Addendum No.: 02

June 10, 2019

CT DAS ● Construction Services ● Office of Legal Affairs, Policy, and Procurement

SCSU Residence Hall Shelf Angle Repairs SCSU, New Haven CF-RS-358

| mark | date | description | drawing prepared by | CHRISTOPHER WILLIAMS ARCHITECTS | 85 Willow Street, Building 54 | As indicated | As indicated | As indicated | As indicated | Project | SCSU RESIDENCE HALL SHELF ANGLE | REPAIRS | SCSU, NEW HAVEN, CT | drawing no. | A502

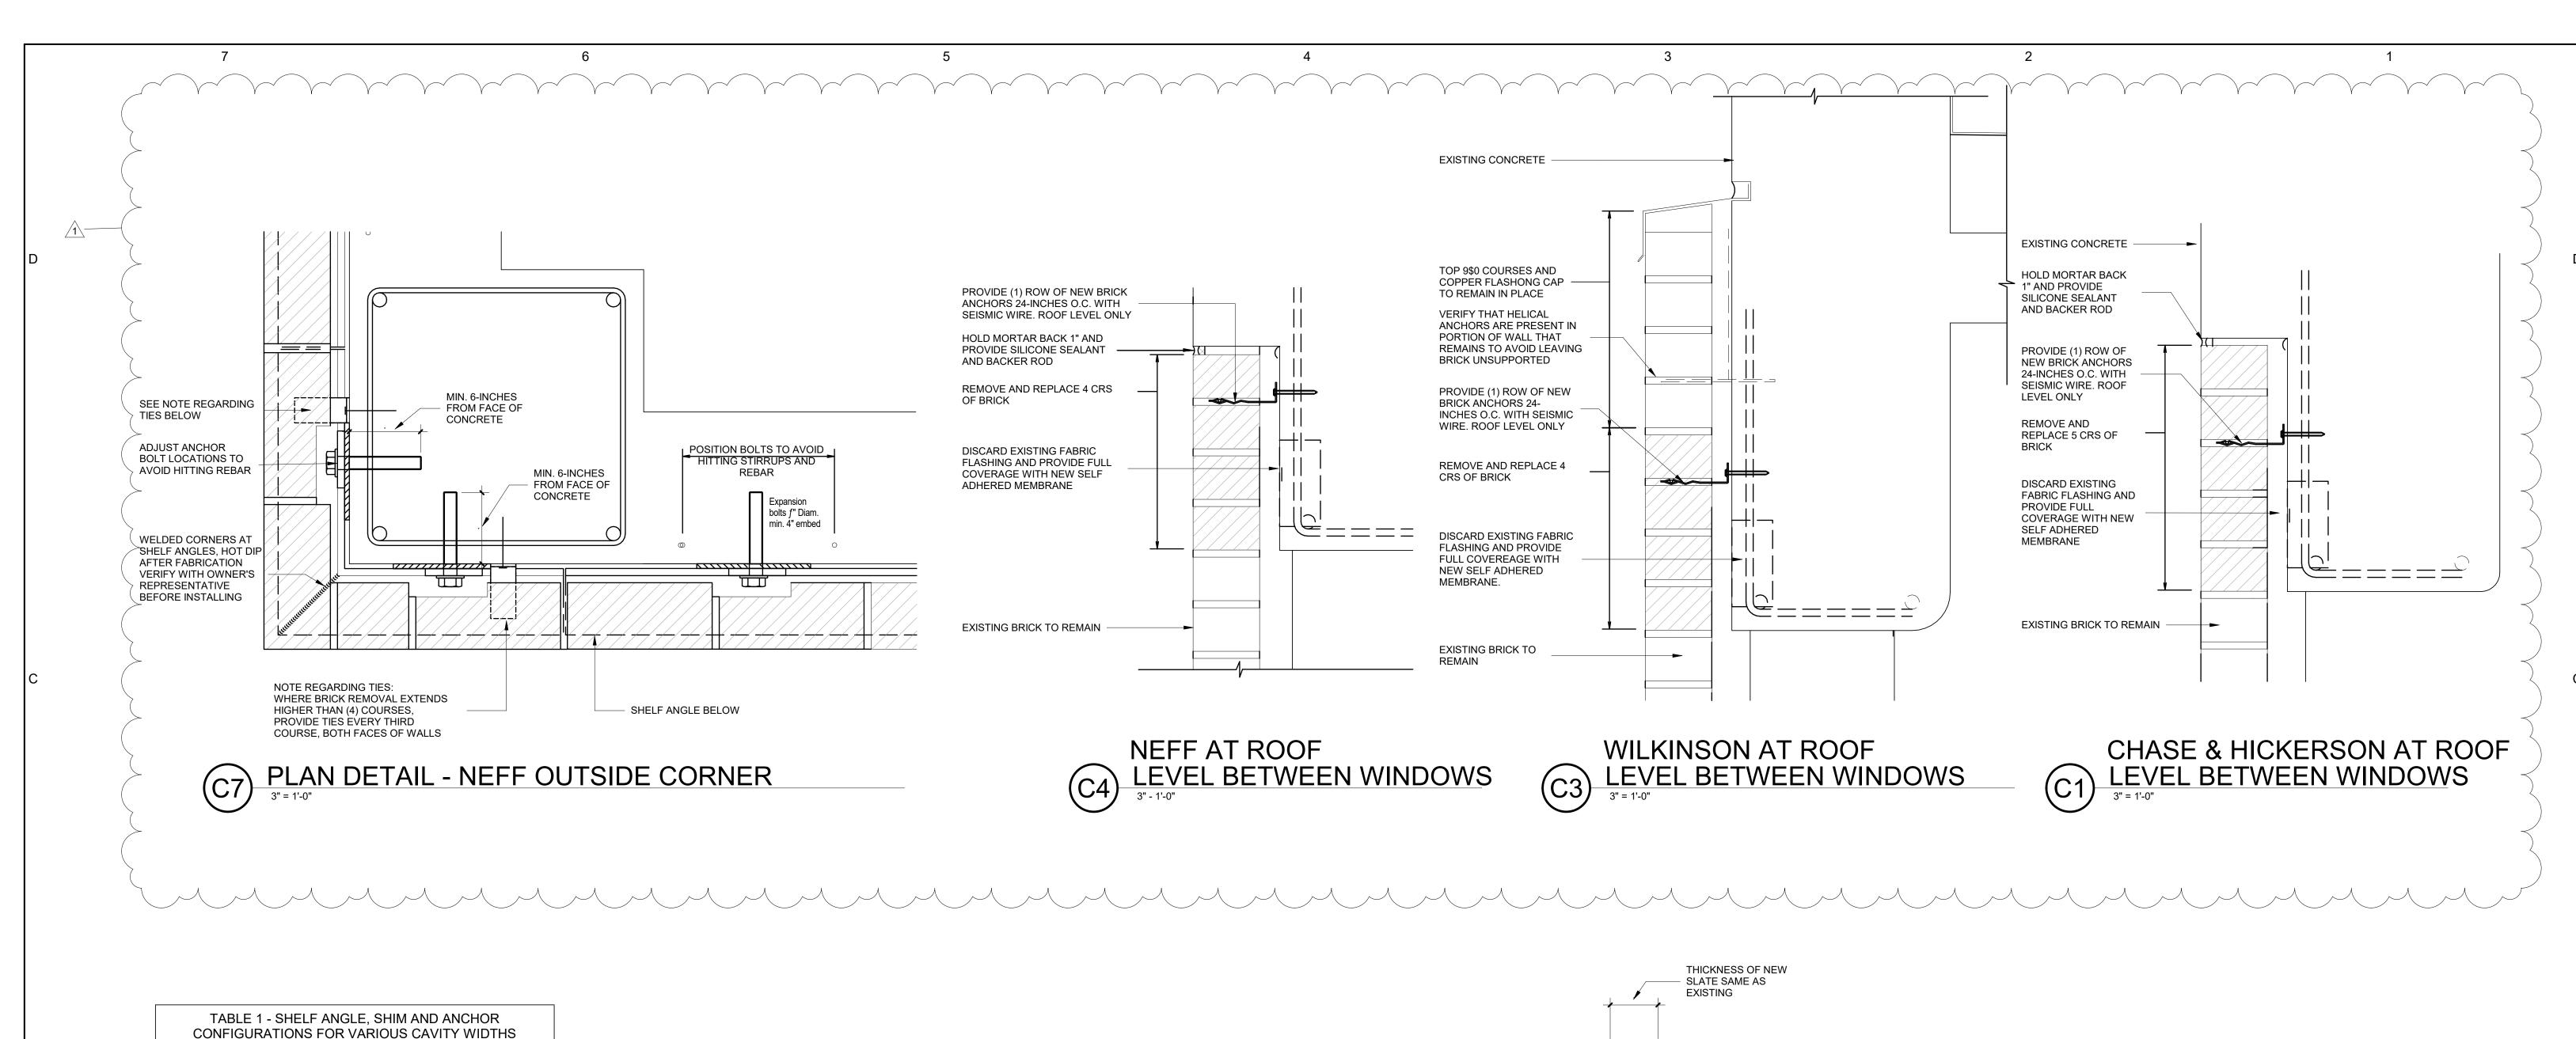
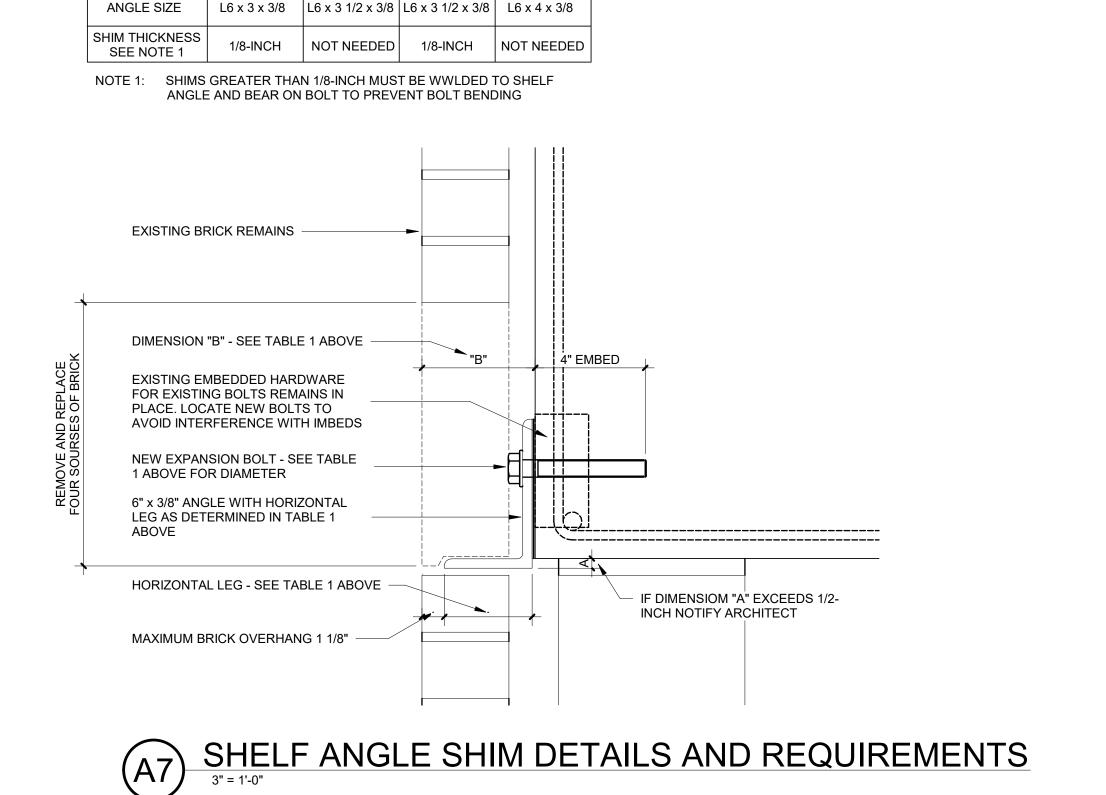
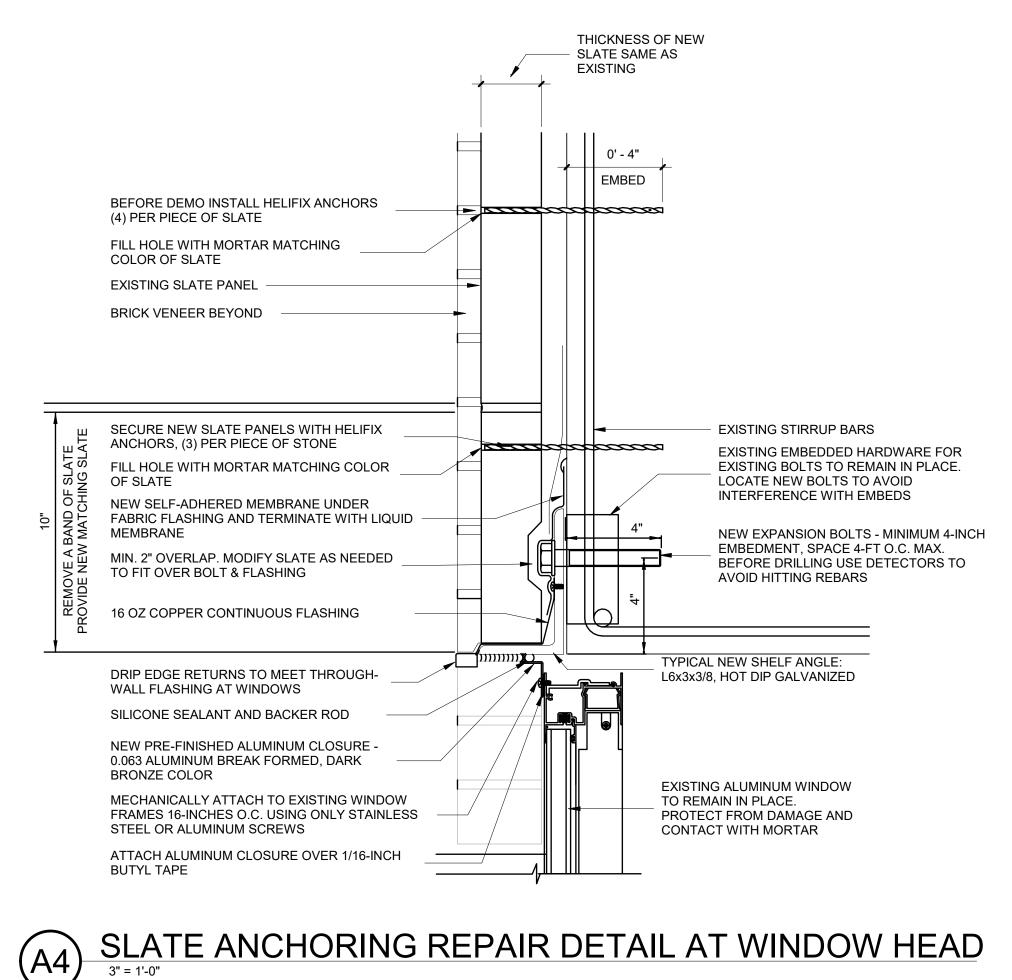
RFI Question: Please provide a detail for the brick replacement at the roof level, at locations adjacent to the windows, where no loose lintel is to be installed.

RFI Question: Please provide a corner detail for the brick replacement at Neff Hall.

Response: See Addendum 02 Sheet A502 for requested details that are keyed into Addendum 02 Sheets A211, A221, A231 and A241

Response: See Addendum 02 Sheet A502 for requested detail that is keyed into Addendum 02 Sheet A241
